**Skills Canada Mobile Robotics
Toronto 2025
Competitor Questions and Responses Document**

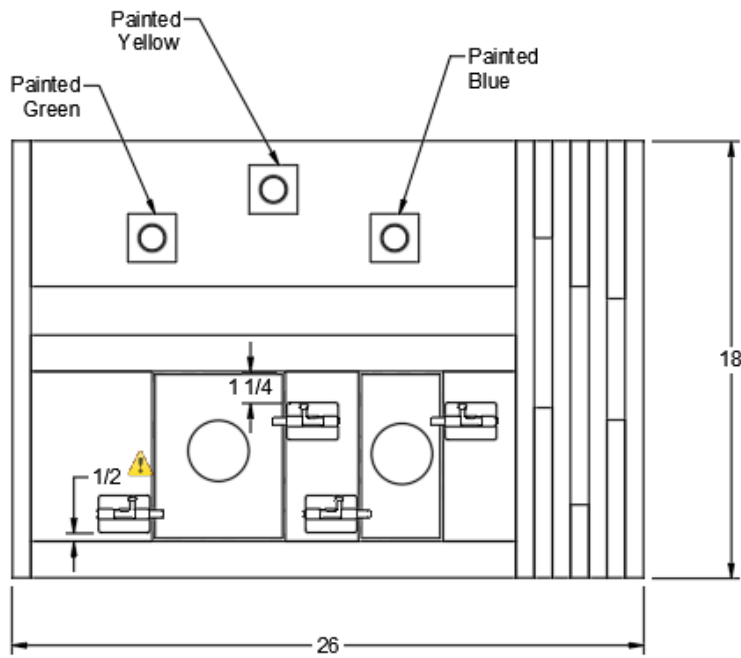
Q: What configuration will the barrel bolts be in at the start of the game?

R: The barrel bolts will start closed across the front of the transformers and the knob will be in the down or horizontal position such that the bolt can be slid without needing to be rotated.
